Accessibility Self-Evaluation and Transition Plan

LAVA BEDS

NATIONAL MONUMENT | CA

AUG 2015

Site Map

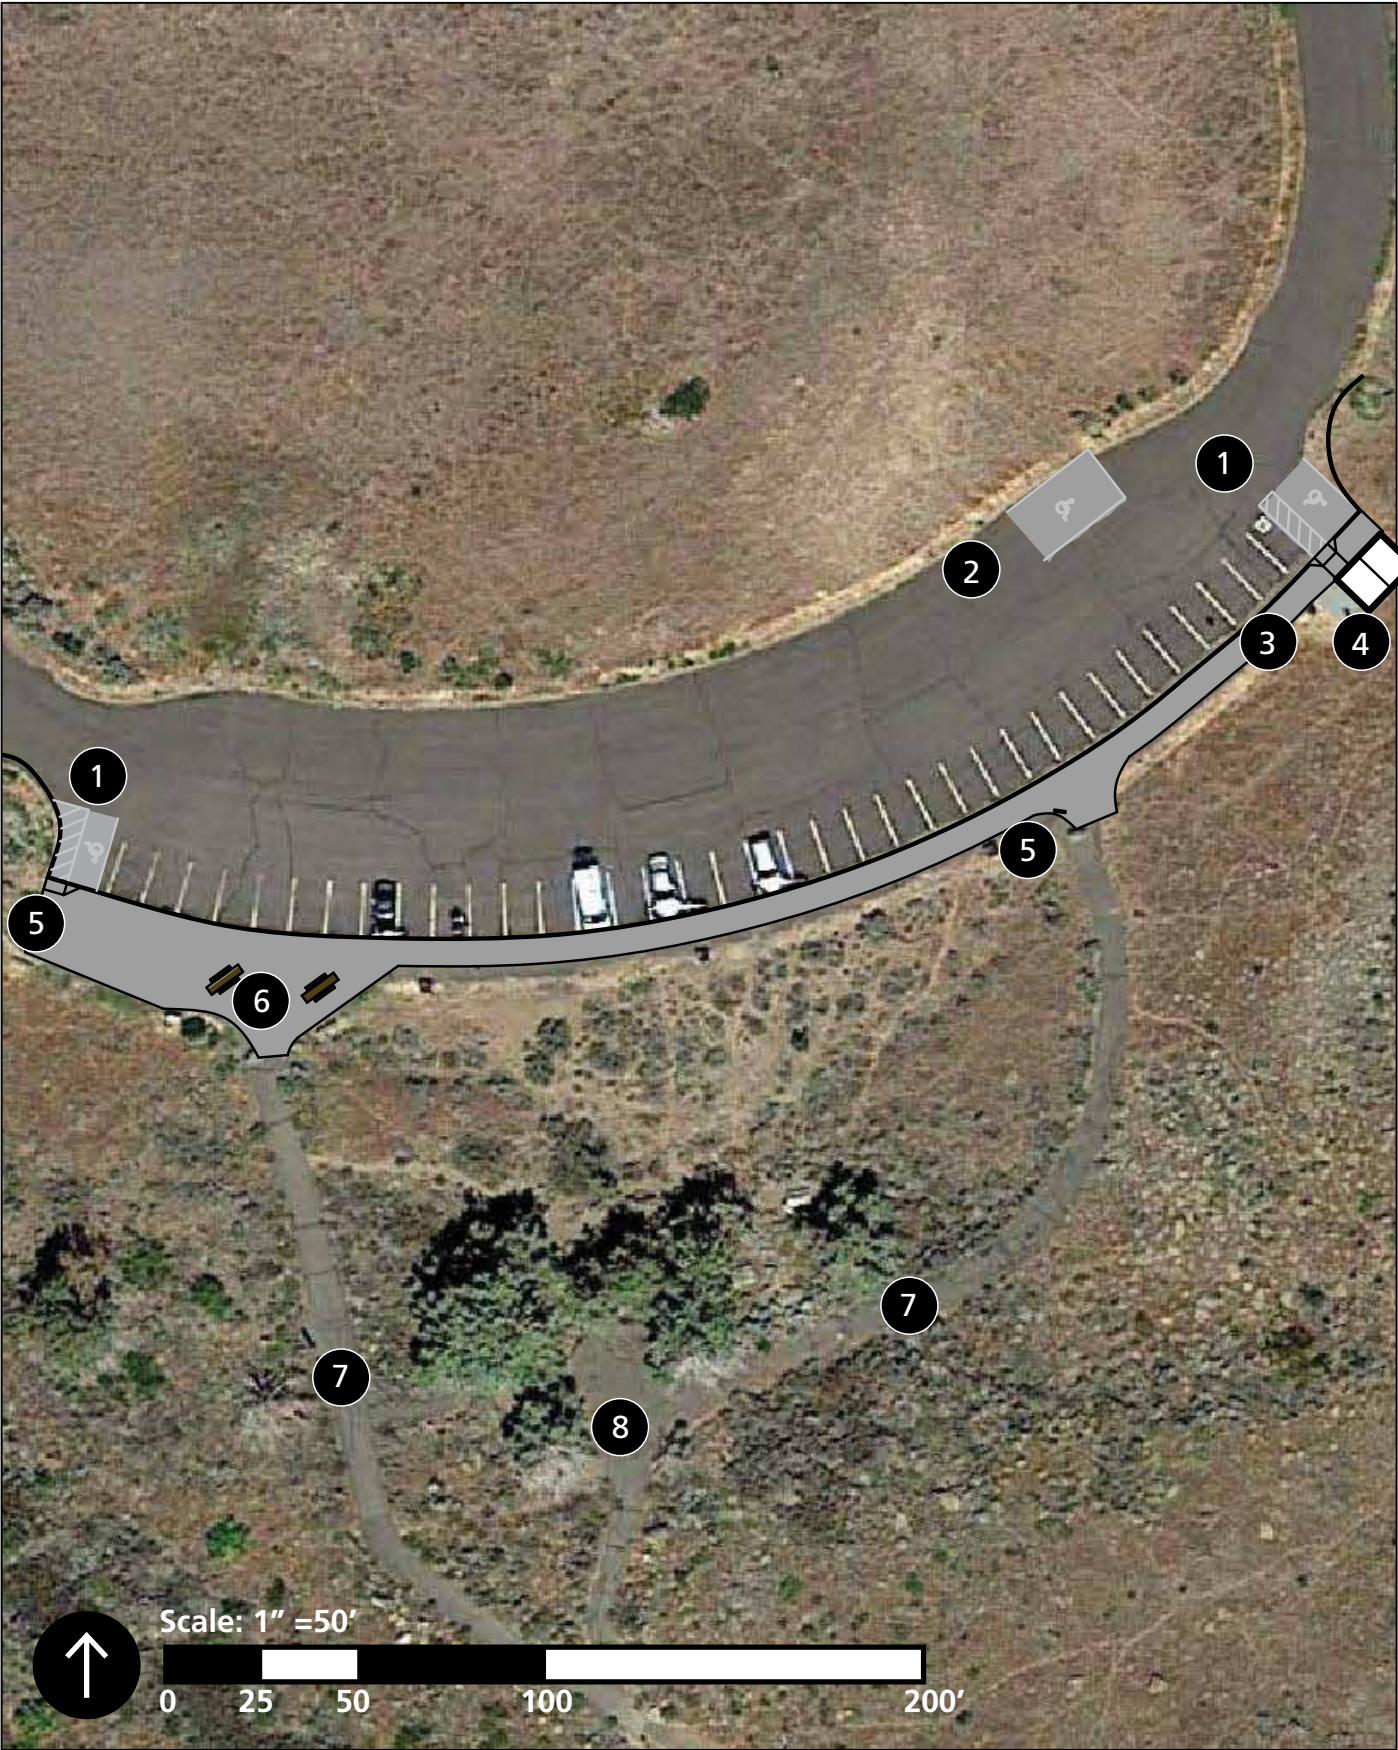
Service, Activity, or Program	Level of Access				PAMP Optimizer Band ±	Barrier	Solution	Proximity to Other Recommended Solutions ∞
	Cognitive	Mobility	Vision	Hearing				
Car Parking	1	2	2	1	3	No accessible parking space and no van accessible parking space provided.	1) Provide one signed and marked "van accessible" parking stall and one signed and marked standard accessible parking stall near restroom. 2) Pave an additional van accessible stall on the western end of the parking lot. Stalls should be maximum 2% running and cross slopes, 5' marked access aisle, and 11' wide van accessible stall, and 8' wide for vehicle stall. Provide access aisle on the passenger side of the van and driver side of the vehicle. 3) Provide firm and stable surface at stall and restrooms. 4) Provide "van accessible" signage with bottom of sign at 60" minimum at van accessible stalls and another accessible sign at the standard accessible stall.	Captain Jack's Stronghold

Service, Activity, or Program	Level of Access				PAMP Optimizer Band ±	Barrier	Solution	Proximity to Other Recommended Solutions ∞
	Cognitive	Mobility	Vision	Hearing				
Oversized Vehicle Parking	1	2	2	1	3	No recreational vehicle (RV) or bus parking spaces striped.	1) Provide striping for RV or bus parking spaces. Accessible space should be 16' wide measured to centerline of striping or face of curb and a maximum slope of 2% in all directions. 2) The curb ramp between parking and sidewalk should have a running slope of 8.33% maximum and a cross slope of 2%. The curb ramp should have a 36" minimum landing at the top with a running slope and cross slope of 2% maximum. Curb ramp flared side slopes should be 10% or less. 3) Install parking space signs to be 60" minimum above the finished ground surface to the bottom of the sign.	Captain Jack's Stronghold

Service, Activity, or Program	Level of Access				PAMP Optimizer Band ±	Barrier	Solution	Proximity to Other Recommended Solutions ∞
	Cognitive	Mobility	Vision	Hearing				
Hiking Trail	1	3	2	1	2	The current route is very steep and is not accessible.	Due to steep grades and cultural resource sensitivity (ABAAS 1019.1 and 1017.1 Exception 1), the hiking trail is not accessible. Subsequent planning and design is needed to provide an understanding of potential alternate routes for an accessible trail to the upper part of the site. 1) Create a firm and stable trail surface where possible. 2) Provide trailhead information signage on trail conditions (length of the trail or trail segment, surface type, typical and maximum tread width, typical and maximum running slope, and typical and maximum cross slope) per Architectural Barriers Act Accessibility Standards section 1017.10.	Captain Jack's Stronghold

Viewing Areas	1	2	1	1	2	Route to the battle viewing area is steep and not accessible.	1) Due to steep topography and cultural resource sensitivity (ABAAS 1019.1 and 1015.1 Exception), the existing viewing area is not accessible. Relocate viewing area onto a firm and stable area near the trailhead (in vicinity of site plan locations 5 and 6).	Captain Jack's Stronghold

Service, Activity, or Program	Level of Access				PAMP Optimizer Band ±	Barrier	Solution	Proximity to Other Recommended Solutions ∞
	Cognitive	Mobility	Vision	Hearing				
Picnic Facilities	1	2	2	1	2	The trail to the tables is too steep and is not accessible.	1) Due to steep grades and cultural resource sensitivity (ABAAS 1019.1 and 1011.2 Exception), the existing viewing area cannot be made accessible. Subsequent planning and design is needed to provide an appropriate location for the picnic facility. Subsequent planning and design is needed to provide an appropriate location for the picnic facility. 1) Add two accessible tables near the trailhead that have integrated seating spaces on the ends or middles with 36" clear space and firm and stable surfaces around each table. 2) Provide shade for one of the two tables.	Captain Jack's Stronghold
Men's Restroom	1	2	2	1	3	The door to the restroom is too heavy, and the sign is not in the correct location.	1) Replace signage to the left side of the doors between 48" and 60" above the finish floor. 2) Add braille identification to signage.	Captain Jack's Stronghold

Women's Restroom	1	2	2	1	3	The door to the restroom is too heavy.	1) Replace signage to the left side of the doors between 48" and 60" above the finish floor. 2) Add braille identification to signage.	Captain Jack's Stronghold

Service, Activity, or Program	Level of Access				PAMP Optimizer Band ±	Barrier	Solution	Proximity to Other Recommended Solutions ∞
	Cognitive	Mobility	Vision	Hearing				
Outdoor Recreation Access Route and Walking Surfaces	1	2	1	1	3	No access to sidewalk from parking stall.	1) Provide curb cuts from proposed parking stall access aisles to sidewalk. Curb cuts to meet requirements in ABAAS section 406.	Captain Jack's Stronghold
Interpretive Waysides and Trailhead Kiosk	2	2	2	2	3	Text is difficult to read, and there is not a 70% contrast between all text and images in the background. Some italicized text on the panel, and not all fonts maintain 24 point (with the exception of 16 point font for labeling photos). The clear space in front of the panel exceeds the maximum 2% slope. Route to the signage is also not accessible.	1) Due to steep grades and cultural resource sensitivity (ABAAS 1019.1 and 1017.1 Exception 1), the existing location of interpretive signage and trailhead kiosk cannot be made accessible. Provide alternate locations for installation of new signage adjacent to parking lot where grades are flatter. Avoid all caps in panel text when panel is replaced and ensure that future graphics are clear and contrast with background color of panel. 2) Add braille identification to entrance signage.	Captain Jack's Stronghold; all interpretation signage throughout park

- 1 Car Parking.** 1) Provide one signed and marked "van accessible" parking stall and one signed and marked standard accessible parking stall near restroom. 2) Pave an additional van accessible stall on the western end of the parking lot. Stalls should be maximum 2% running and cross slope, 5' marked access aisle and 11' wide van accessible stall, and 8' wide for vehicle stall. Provide access aisle on the passenger side of the van and driver side of the vehicle. 3) Provide firm and stable surface at stall and restrooms. 4) Provide "van accessible" signage with bottom of sign at 60" minimum at van accessible stalls and another accessible sign at the standard accessible stall.

- 2 Oversize Vehicle Parking.** Provide striping for RV or bus parking spaces. Accessible space should be 16' wide measured to centerline of striping or face of curb and a maximum slope of 2% in all directions. 2) The curb ramp between parking and sidewalk should have a running slope of 8.33% maximum and a cross slope of 2%. The curb ramp should have a 36" minimum landing at the top with a running slope and cross slope of 2% max. Curb ramp flared side slopes should be 10% or less. 3) Install parking space signs to be 60" minimum above the finished ground surface to the bottom of the sign.

- 3 Outdoor Recreation Access Route and Walking Surfaces.** 1) Provide several curb cuts from proposed parking stall access aisles to sidewalk. Curb cuts to meet requirements in ABAAS section 406.

- 4 **Restrooms.** 1) Replace signage to the left side of the doors between 48" and 60" above the finish floor. 2) Add braille identification to signage.

- 5 **Interpretive Waysides and Trailhead Kiosk.** 1) Due to steep grades and cultural resource sensitivity (ABAAS 1019.1 and 1017.1 Exception 1), the existing location of interpretive signage and trailhead kiosk cannot be made accessible. Provide alternate locations for installation of new signage adjacent to parking lot where grades are flatter. Avoid all caps in panel text when panel is replaced and ensure that future graphics are clear and contrast with background color of panel. 2) Add braille identification to entrance signage.

- 6 **Picnic Facility.** Due to steep grades and cultural resource sensitivity (ABAAS 1019.1 and 1011.2 Exception), the existing viewing area cannot be made accessible. Subsequent planning and design is needed to provide an appropriate location for the picnic facility. 1) Add two accessible tables near the trailhead that have integrated seating spaces on the ends or middles with 36" clear space and firm and stable surfaces around each table. 2) Provide shade for one of the two tables.

- 7 **Hiking Trail (continues off map to the south).** Due to steep grades and cultural resource sensitivity (ABAAS 1019.1 and 1017.1 Exception 1), the hiking trail is not accessible. Subsequent planning and design is needed to provide an understanding of potential alternate routes for an accessible trail to the upper part of the site. 1) Create a firm and stable trail surface where possible. 2) Provide trailhead information signage on trail conditions (length of the trail or trail segment, surface type, typical and maximum tread width, typical and maximum running slope, and typical and maximum cross slope) per Architectural Barriers Act Accessibility Standards section 1017.10.

- 8 **Viewing Areas.** Due to steep topography and cultural resource sensitivity (ABAAS 1019.1 and 1015.1 Exception), the existing viewing area is not accessible. Relocate viewing area onto a firm and stable area near the trailhead (in vicinity of site plan locations 5 and 6).

Site Map

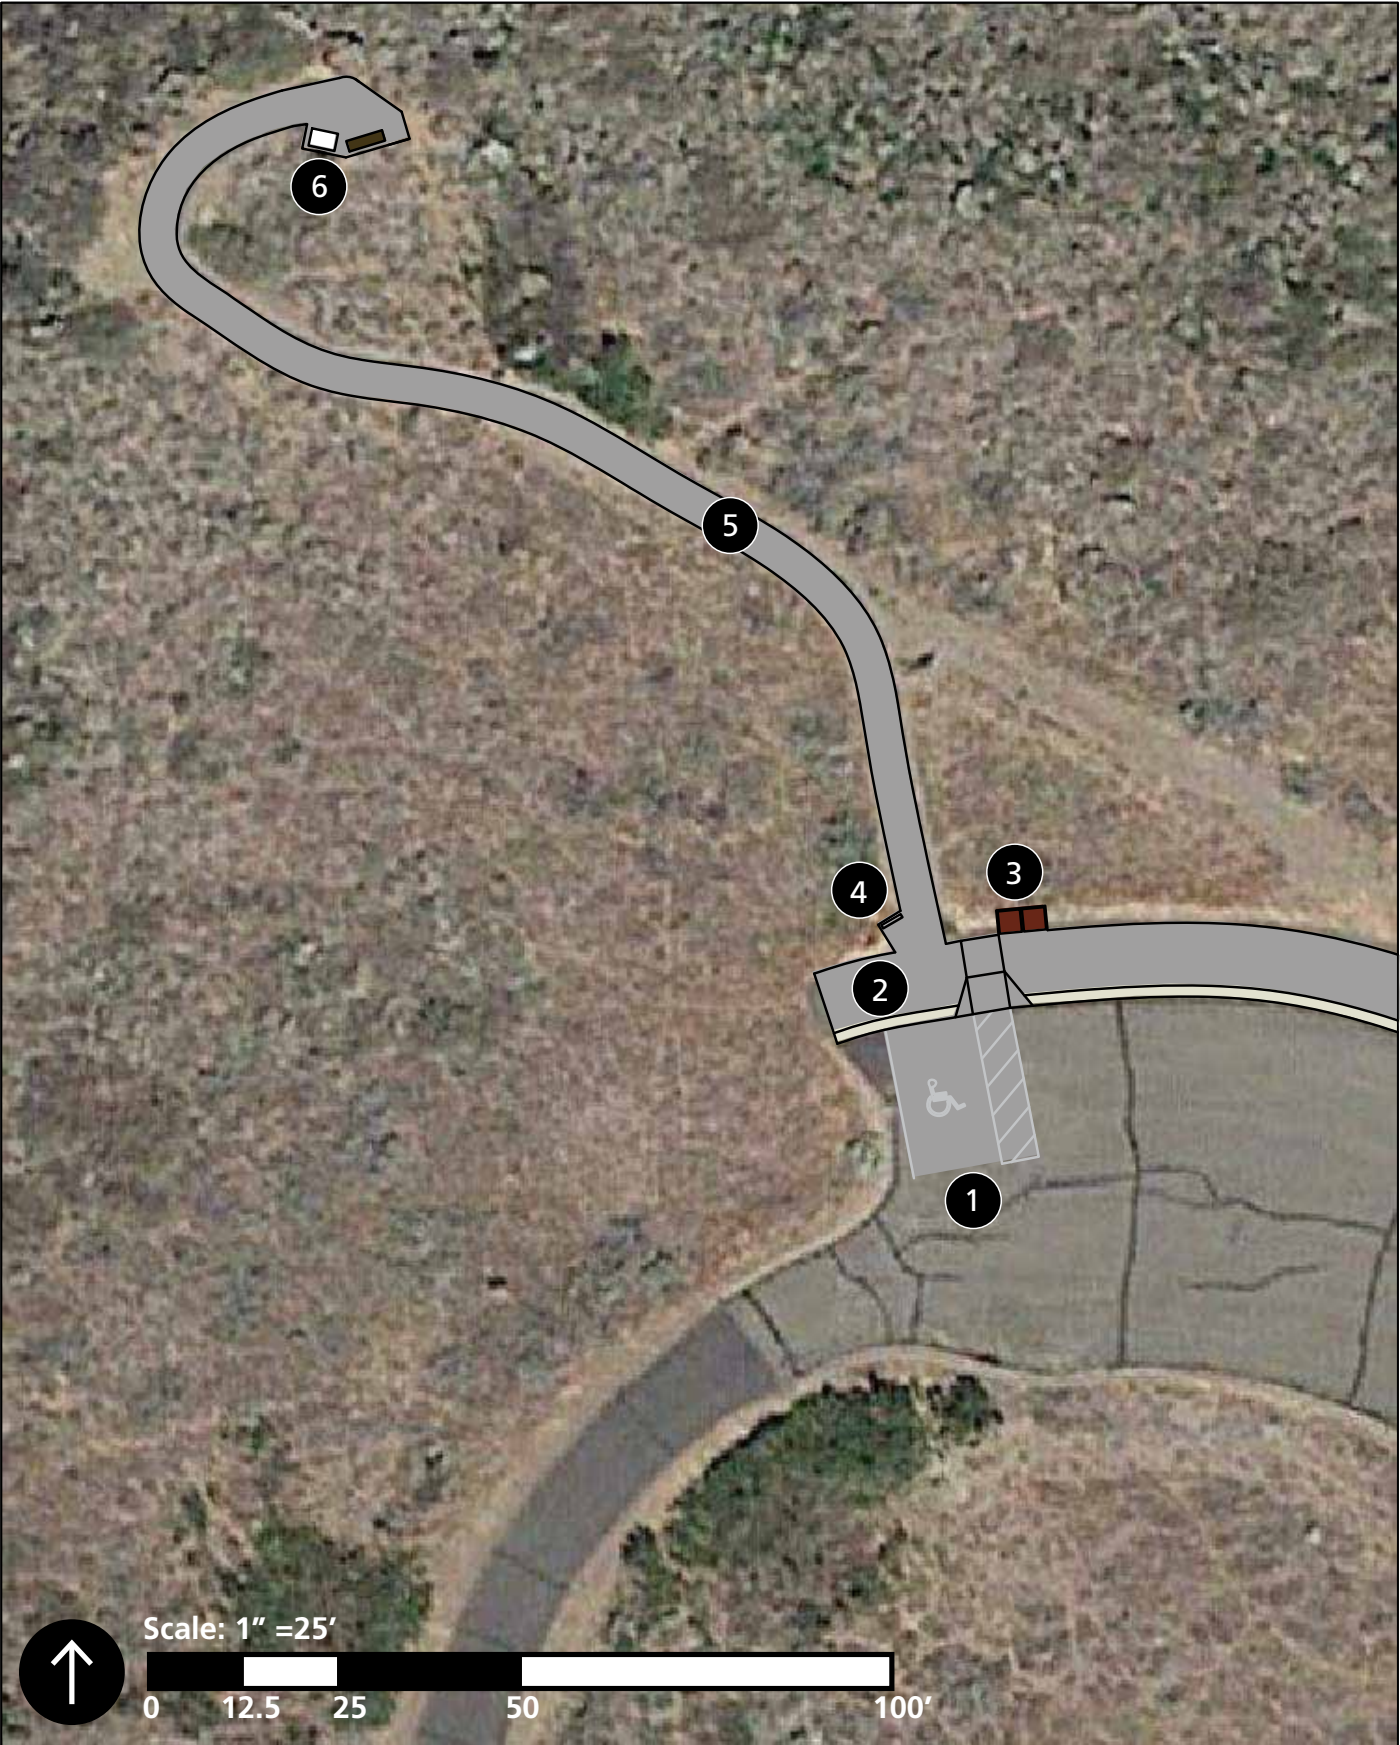
Service, Activity, or Program	Level of Access				PAMP Optimizer Band ±	Barrier	Solution	Proximity to Other Recommended Solutions ∞
	Cognitive	Mobility	Vision	Hearing				
Trash and Recycling	2	2	2	2	3	Trash receptacle does not provide a firm and stable landing and is not operable with a closed fist.	1) Make the surface firm, nonslip, and stable, and replace trash receptacle with one that requires less than five pounds to open and is operable with a closed fist. 2) Ensure that there is clear ground space in front of the trash receptacle, 30" minimum for front approach, and 60" minimum for side approach.	Devils Homestead Pullout
Hiking Trail	1	2	1	1	3	Some cracking in the trail needs repair because the cracks exceed a 1/2" gap. The terminus of the trail is too narrow to turn around. No trailhead information signage to provide trail conditions.	1) Repair cracks in the asphalt. 2) Provide a 5' by 5' turning space at the end of the hiking trail at 2% slope in all directions. 3) Provide a 5' by 5' turning space at the viewing area with 2% slope in all directions. 4) Provide a bench for resting at the end of the hiking trail with a companion seating area (36" by 48") on a firm and stable surface.	Devils Homestead Pullout

Interpretive Wayside	2	1	2	2	3	The font size is too small.	1) Ensure all font size on panels is 24 point (16 point for labeling photos).	Devils Homestead Pullout; all interpretation signage throughout park
Trailhead Kiosk	1	2	1	1	3	No trailhead information signage provided on conditions of trail.	1) Provide trailhead information signage on trail conditions (length of the trail or trail segment, surface type, typical and maximum tread width, typical and maximum running slope, and typical and maximum cross slope) per Architectural Barriers Act Accessibility Standards section 1017.10.	Devils Homestead Pullout

- 1 **Car Parking.** 1) Provide one signed and marked "van accessible" parking stall. Stall should be maximum 2% running and cross slope, 5' marked access aisle and 11' wide van accessible stall. Provide access aisle on the passenger side of the van. 2) Provide firm and stable surface at stall and up to restrooms, trailhead kiosk, picnicking area, etc. 3) Provide "van accessible" signage with bottom of sign at 60" minimum above the finish ground.

- 3 **Trash and Recycling.** 1) Make the surface firm and stable and replace with trash receptacle that requires less than five pounds to open and is operable with a closed fist. 2) Ensure that there is clear ground space in front of the trash receptacle, 30" minimum for front approach and 60" minimum for side approach.

- 4 **Trailhead Kiosk.** 1) Provide trailhead information signage on trail conditions (length of the trail or trail segment, surface type, typical and maximum tread width, typical and maximum running slope, and typical and maximum cross slope) per Architectural Barriers Act Accessibility Standards section 1017.10.

- 5 **Hiking Trail.** 1) Repair cracks in the asphalt. 2) Provide a 5' by 5' turning space at the end of the hiking trail at 2% slope in all directions. 3) Provide a 5' by 5' turning space at the viewing area with 2% slope in all directions. 4) Provide a bench for resting at the end of the hiking trail with a companion seating area (36" by 48") on a firm and stable surface.
